AERO ACCESSORIES, INC.  
**SERVICE BULLETIN**

**SERVICE BULLETIN: SB-009**  
**SUBJECT: Possible Loose Contact Button.**  
**APPLICABILITY: Contact Assembly A-13081.**

**Affected part:** Contact Assembly A-13081

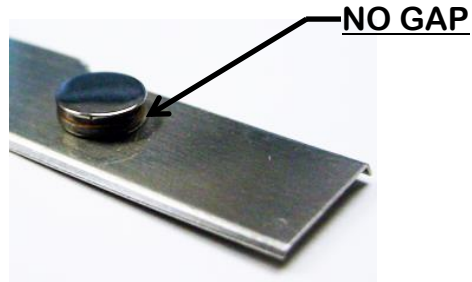
CONTACT BASE TOUCHING  
SPRING AROUND ENTIRE  
CIRCUMFERENCE  
NO GAPS

- b. The contact button must be tightly riveted to spring element and exhibit no evidence of looseness. There must be no gap between the underside of the contact button and the spring or base.

- c. Measure the diameter of the upset shop head of the rivet. It must be no less than .130 inch in diameter.

$\phi$ .150  
.130  
SPRING CONTACT  
BUTTON SHOP HEAD

- d. If there is any evidence of looseness of the contact button, and/or a gap exists under the contact button, and/or the diameter of the upset head of the contact button is less than .130 inch, remove and replace the contact assembly with a contact assembly having a date code other than those affected by this bulletin.
